**Objections to the 'soundness' of
July 2013 AMENDMENTS to
SLDC's *Land Allocation Development Plan
Document (LADPD)*
for Grange-over-Sands and district**

SLDC documents:

Submitted by:

Valerie H Kennedy

Map 1 SLDC's proposed development sites on the western side of Grange-over-Sands and Kents Bank highlighting the Jack Hill junction.

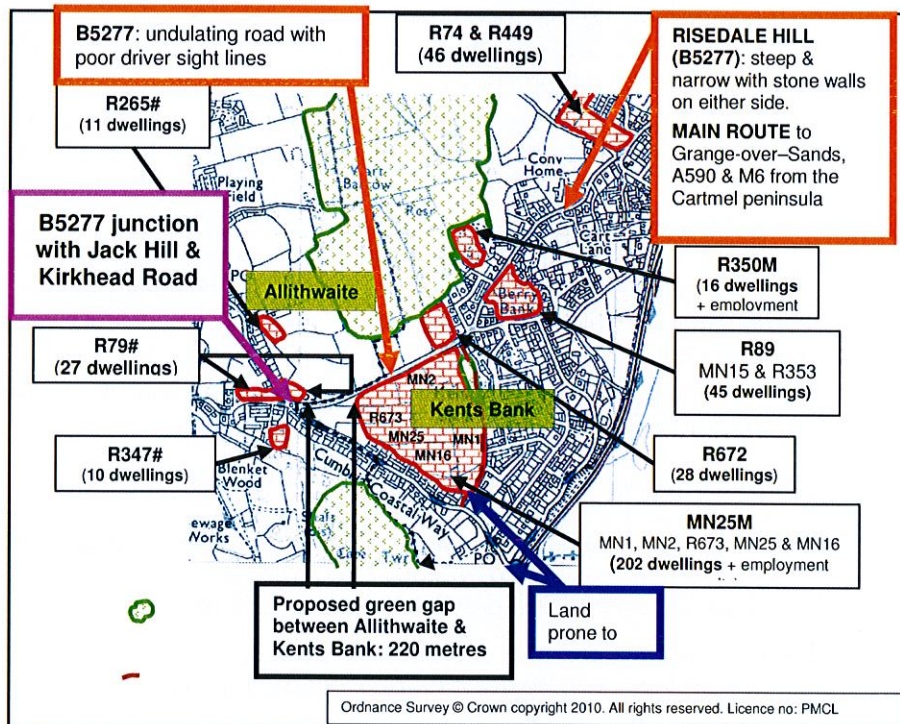
- 3.3 This is a meaningless statement. It does not take account of the limited access from Bankfield to Jack Hill, a narrow 'access only' road; nor does it make clear that the nearby Jack Hill junction with the B5277 (main through road to Grange-over-Sands, the A590 and the M6) is on a 90° bend adjacent to the junction with the top of Kirkhead Road (Map 1).

- 3.4 If developments on the land north of Bankfield and the land north of Jack Hill are permitted it will be necessary to completely re-design/re-build this multiple road junction which will be a major undertaking (Map1).

- 3.6 The turn into Kirkhead Road is has an awkward angle (>90°, Map 1), the turn into Jack Hill is onto a narrow 'no through road', and, access roads are required on either side of the B5277 to the site north of Jack Hill (Map 1).

- 2.8 There is no mention in *SLDC's* amendments of the need to provide safe access for pedestrians and cyclists. There are no footpaths on Jack Hill and access for pedestrians and cyclists is hazardous.
- 2.9 *SLDC's* recommendation of land behind Bankfield for development of ten dwellings is not sound due to significant site access and road safety problems.

- 4.8 In addition, *SLDC's* recommendation to use land north of Jack Hill for a development of 27 dwellings is **NOT SOUND** due to significant site access, land drainage and road safety problems (Map 1).

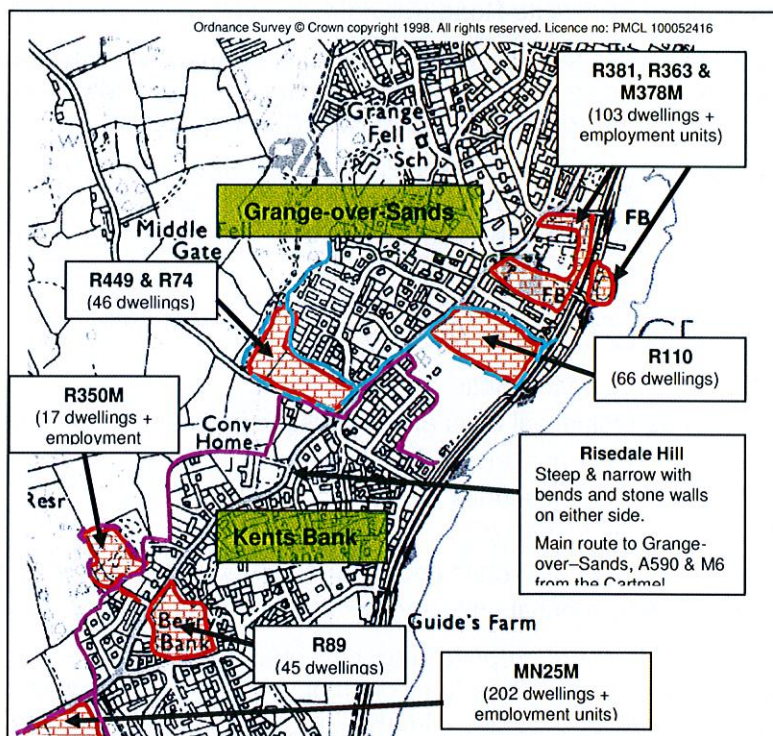
- 3.3 AECOM's comments indicate that their remit from SLDC did not allow them resources to assess the accessibility of R110 adequately.
- 3.4 As can be seen from Map 2 access to Kents Bank Road (B5277 main through road) is onto a stretch of the B5277 where there are already eight other road junctions in less than a quarter of a mile.

- 3.5 Access to Kents Bank Road from Thornfield Road is already difficult; drivers turning right have very poor sight lines for eastbound traffic due to curvature of the road; the traffic from R110 would cause additional problems for drivers, pedestrians and cyclists using Thornfield Road.
